Technical Service Bulletin

Topic	E-Machine temperature fault DTC P0A2E00 Bentayga and Flying Spur (Hybrid) 20-23MY
Market area	Bentley: worldwide (2WBE),China 796 VW Import Comp. Ltd (Vico), Beijing (6796)
Brand	Bentley
Transaction No.	2077783/1
Level	EH
Status	Released for publishing
Release date	May 22, 2025

Figure 1

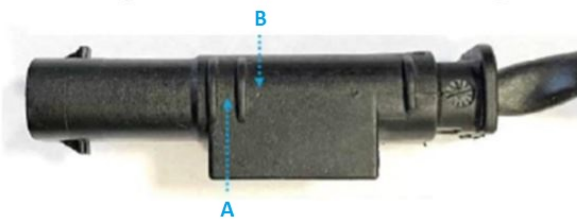
The fault is associated with temperature jumps in the E-Machine temperature sensor. This occurs as a result of sudden changes in resistance in the crimp of the temperature sensor at high temperatures.

E-Machine temperature sensor part replacement is required to resolve the fault. Replacement of E-Machine is not required.

Use figure 1 to help identify old and new level parts. Pay particular attention to the markings shown.

Markings shown by **A** (*indentation between the rib*) = **New level parts**

Markings shown by **B** (*Indentation to the right of the rib*) = **Old level parts**

3. Install the new level electric drive temperature sensor.

Correct part identification is critical to ensure compatibility and reliable system operation after installation.
